ASSESSMENT OF ISSUES AND ALTERNATIVES
ASSOCIATED WITH PROPOSED
GROUND WATER DEVELOPMENT NEAR
GRAND CANYON NATIONAL PARK
AT TUSAYAN, ARIZONA

-DRAFT-

by William L. Jackson

National Park Service
Water Resources Division • Fort Collins, Colorado
September 17, 1993

Figure 1. A conceptualization of the regional aquifer, indicating principal fracture zones (from Errol L. Montgomery and Associates, Inc., 1993).

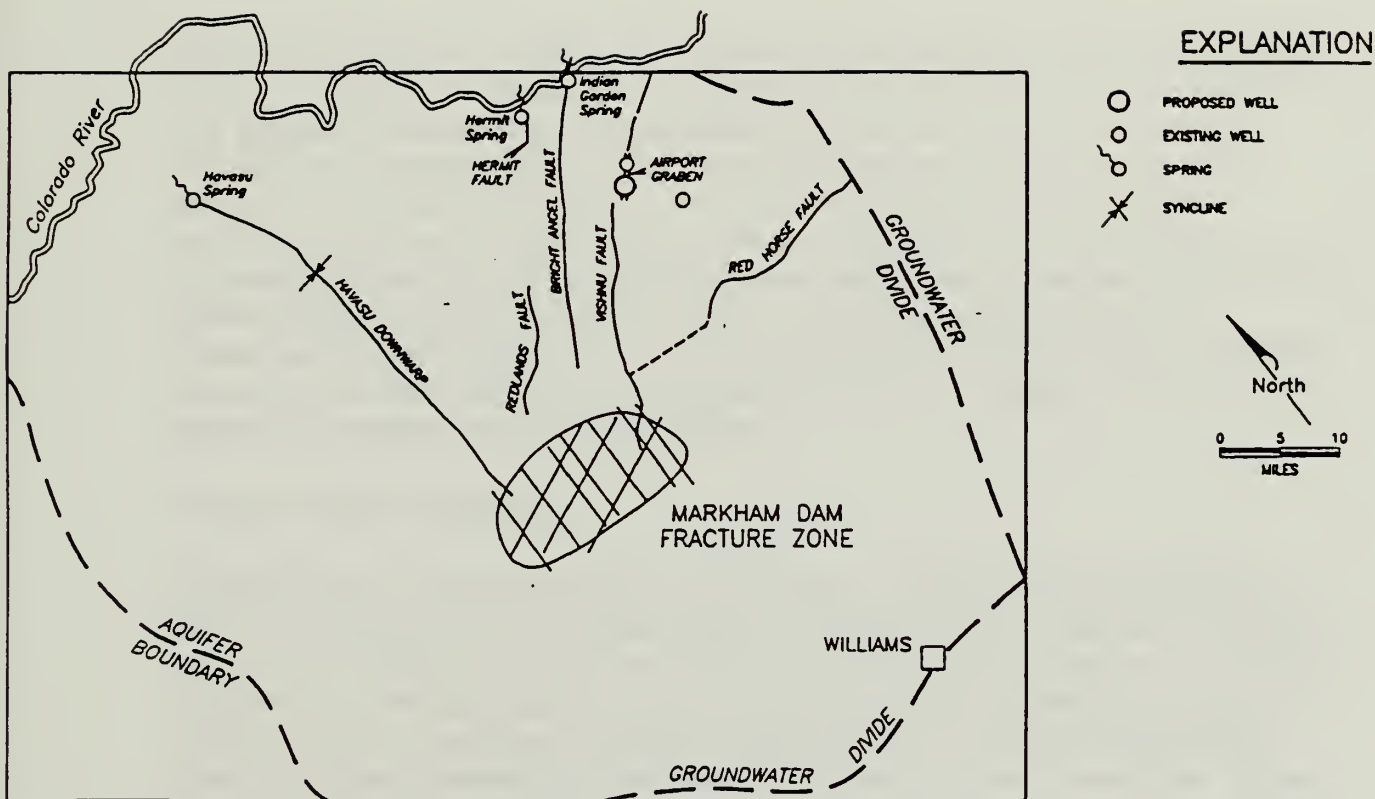
The descriptive model of the aquifer system shows the Havasu Downwarp and the Vishnu and Redhorse fault systems as interconnected with the Markham Dam fracture zone, but the Bright Angel and Redlands faults as disconnected. The basis for this assumption is not provided and its validity cannot be confirmed. However, as discussed below, the accuracy of this assumption may be important in defining the response of the springs to pumping elsewhere in the aquifer.

The Havasu Downwarp is described by Metzger (1961) and interpreted by Montgomery and Associates, Inc. as having large transmissivity and storativity and as the likely source for the large spring at Havasu. The "Markham Dam Fracture Zone" is described in the Montgomery and Associates, Inc. report as a large zone of recharge and water storage for the regional aquifer. Older reports do not mention this large reservoir, but it is also very deep and possibly beyond the limits of previous exploration. Interconnection of this reservoir with springs and the hydrogeologic function of faults has not been previously documented. Again, both the existence of this important recharge/reservoir zone and the existence of an effective hydraulic connection to the Vishnu fault and Airport Graben, is difficult to validate but critical to the prediction of aquifer response to ground water pumping.

Both Hermit and Indian Garden springs are described as associated with fracture zones that are not interconnected with either the Vishnu Fault, or the Airport Graben. Again, the validity of this assumption cannot be confirmed. However, it is very probable that, in addition to the primary fracture zones depicted in the descriptive model of the regional aquifer, there exist hundreds of secondary fractures and solution cavities. It may be impossible to meaningfully characterize secondary fracturing in the regional aquifer or to account for its hydraulic effects within the context of a regional ground water model. However, secondary pathways may be very important in evaluating aquifer response to ground water pumping in specific locations; and especially in locations assumed to be poorly connected hydraulically, to primary zones of water storage and movement.

Assumptions which necessarily went into the characterization of flow paths within the regional aquifer cause concern that the model as presently constructed could misrepresent the potential impacts of pumping on Grand Canyon Springs. Probably the most significant of these assumptions is that Hermit and Indian Garden springs are associated with faults which are not connected to the Vishnu Fault, the Airport Graben or the Markham Dam fracture zone. The assumed lack of effective hydraulic connection between these springs and the Airport Graben serves to "force" the model to draw water from the Vishnu Fault and Markham Dam areas, while minimizing drawdowns in the Bright Angel and Hermit faults.

The second important assumption is that the Airport Graben/Vishnu Fault zones are effectively connected to and recharged by the reservoir assumed to underlay the Markham Dam fracture zone. This assumption is critical for three reasons. First, it permits effective recharge to the Airport Graben during pumping, thus enabling pumping to continue indefinitely at 300 gpm. Second, it minimizes the amount of drawdown in the Airport Graben caused by pumping, further minimizing impacts to local springs. Third, it draws most recharge water from the Markham Dam region; water that primarily is destined to discharge at Havasu Springs.

A third critical assumption is that the Markham Dam fracture zone is, in fact, a significant recharge area for the regional aquifer, and that a significant reservoir of water underlies this zone, and that the reservoir currently is being recharged by infiltration of precipitation. It is the existence of this large fracture zone, in combination with the assumed efficient hydraulic connection to the Airport Graben, which largely causes the model to predict a minimal impact to Hermit and Indian Garden springs, while drawing most recharge water from the Markham Dam/Havasupai Downwarp/Havasupai Spring area.

A "worst case" aquifer conceptualization scenario from the standpoint of potential pumping impacts to park springs should be constructed and modeled. At a minimum, fracturing in the Redwall/Mauv Aquifers should be redefined to show hydraulic connection via secondary fracturing between the Bright Angel Fault and the Airport Graben/Vishnu Fault. Also, secondary fracturing between the Bright Angle Fault and the Markham Dam fracture zone should be assumed to exist. Given a modified conceptualization of the aquifer, the model should be calibrated for the pre-pumping condition and run for pumping locations at Tusayan, and both 10 and 20 miles south of Tusayan.
